ADDENDUM NO. 1

DATE: December 19, 2017
PROJECT: Clowry Grade Bridge #6 Repairs
OWNER: Moose Country Snowmobile Club
BID DATE: Wednesday, December 20, 2017

The following shall be incorporated into the Contract Documents dated **8 DEC. 2017**.

SHEET IDENTIFICATION No. OHM PROJ. 7136-17-0130 C501	ISSUED FOR	DATE	DESIGNED SW
	PRELIMINARY	Dec. 8 2017	DRAWN AR
	CONSTRUCTION		CHECKED ZH
	FINAL RECORD		APPROVED SW

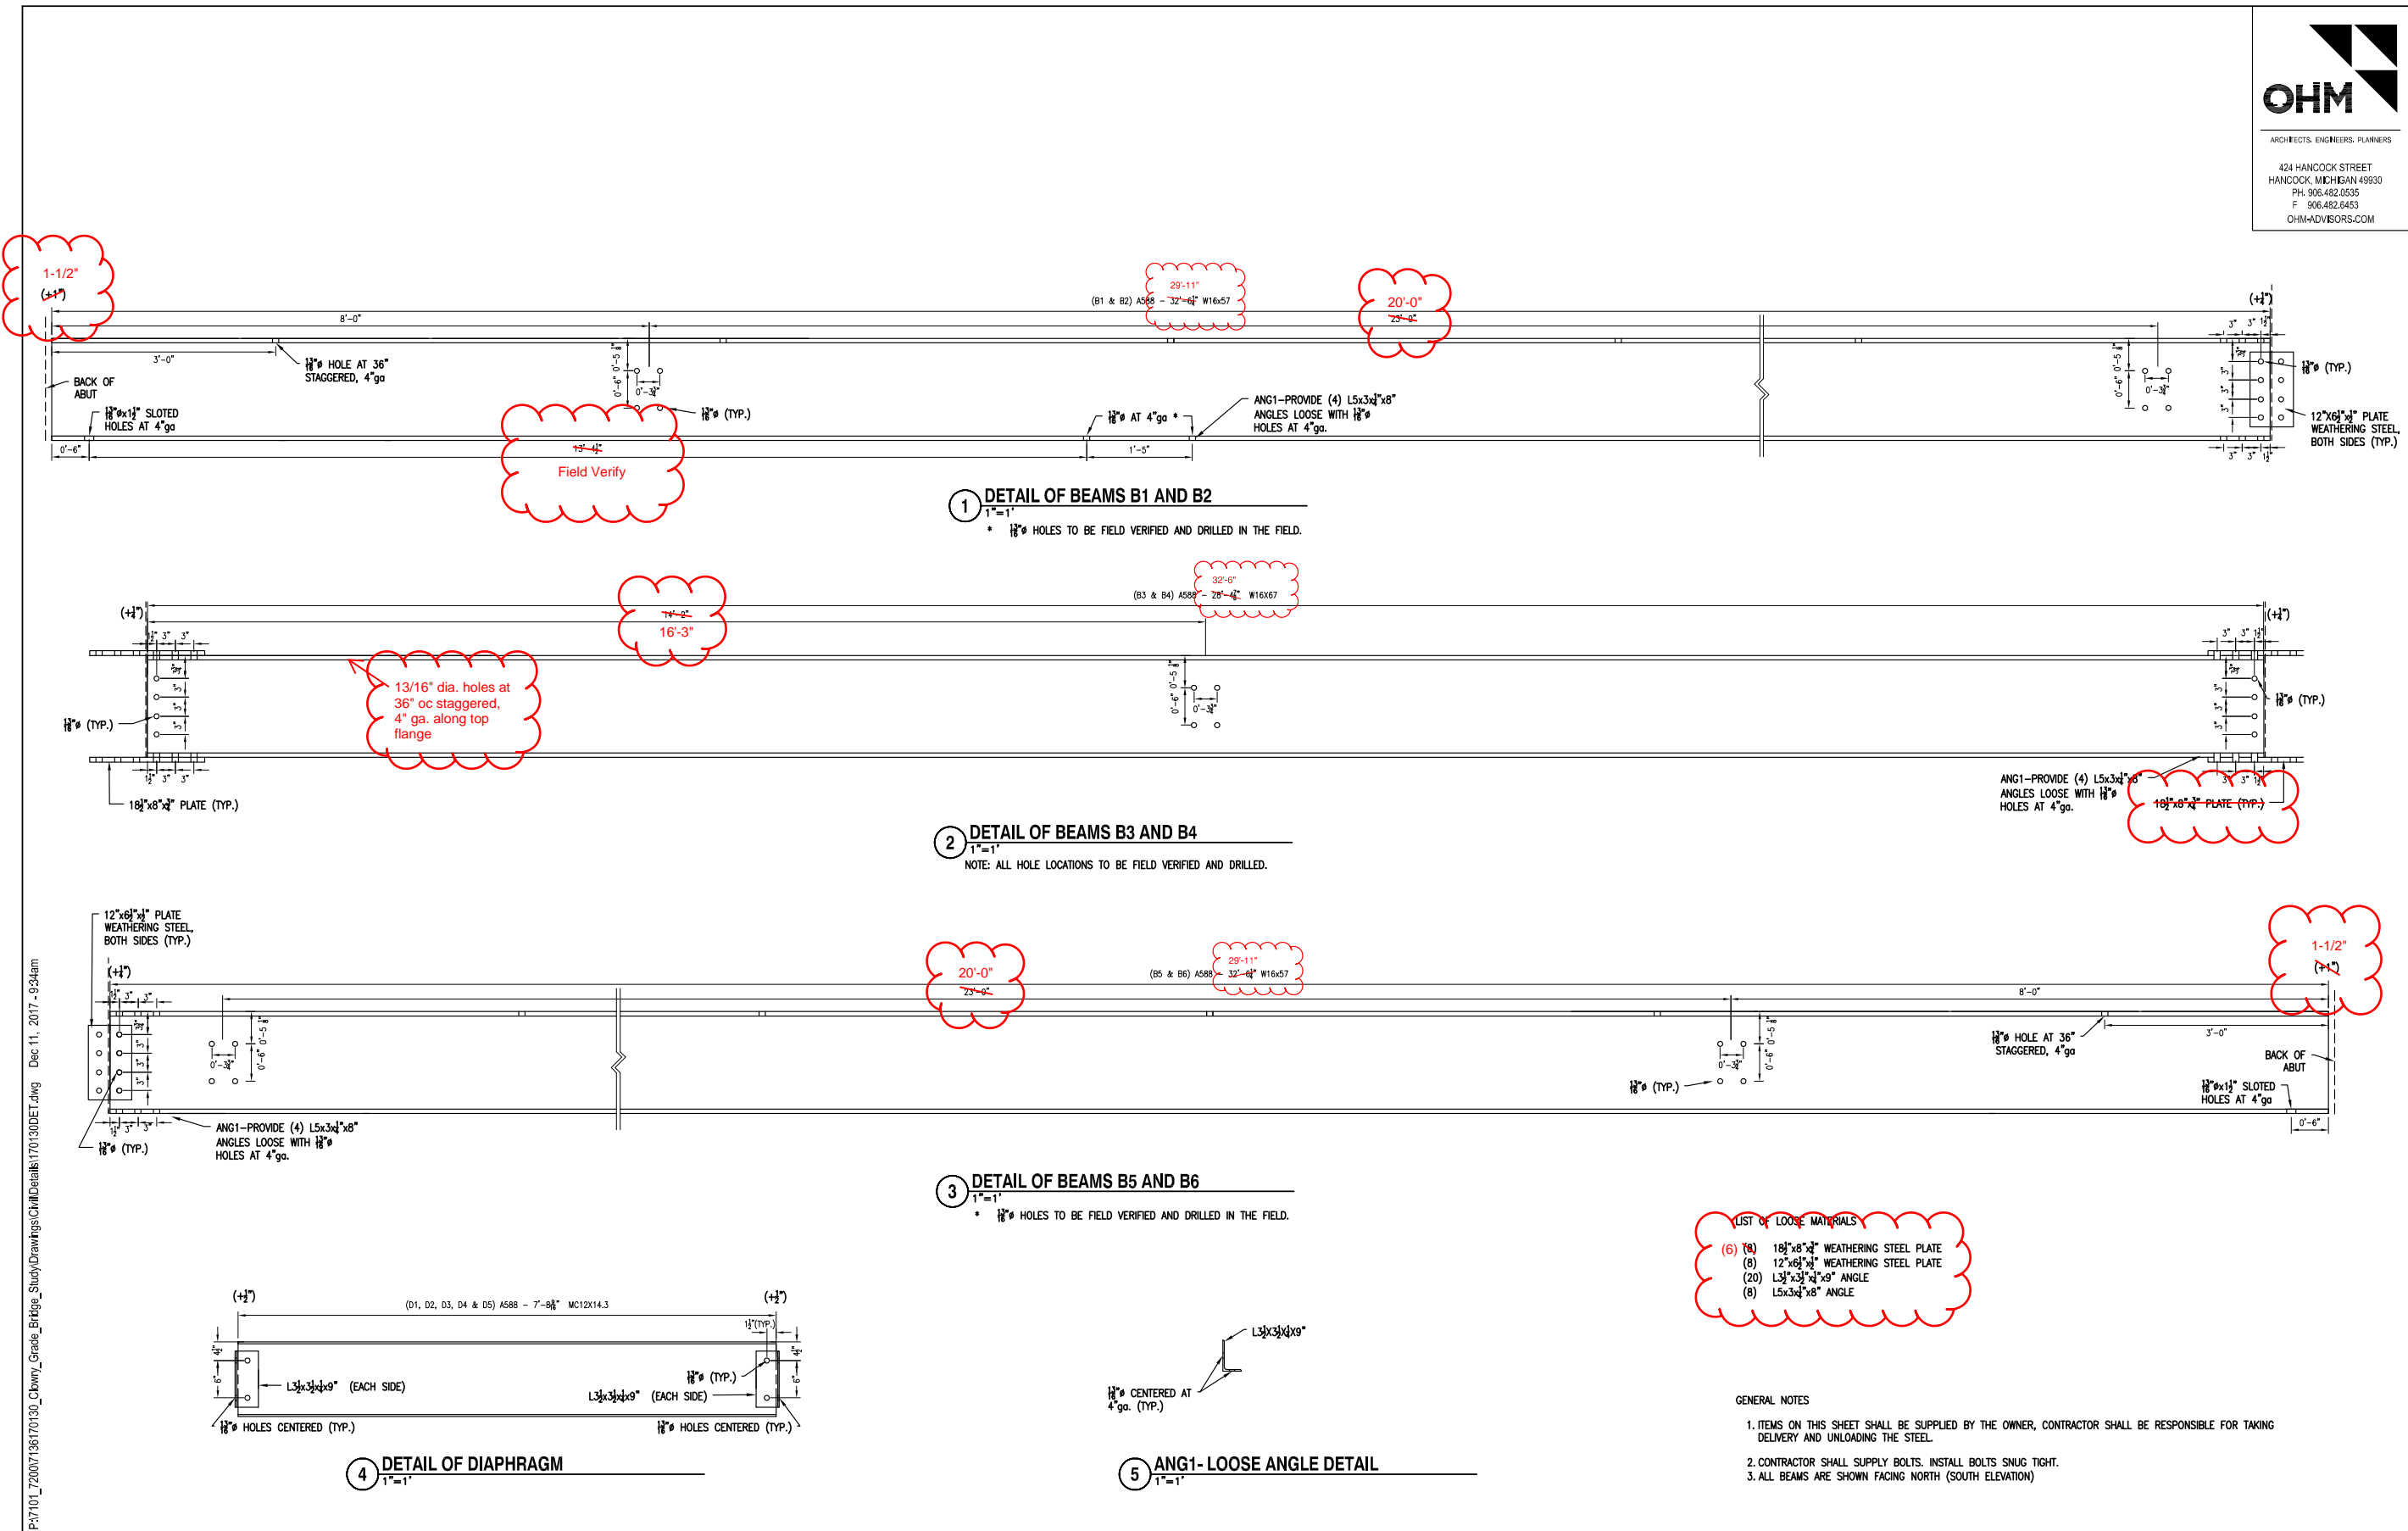
Sheet C501: Adjustments to beam lengths have been made based on field measurements. The number of 18-1/2”x8”x3/4” flange plates has been changed from eight (8) to six (6).
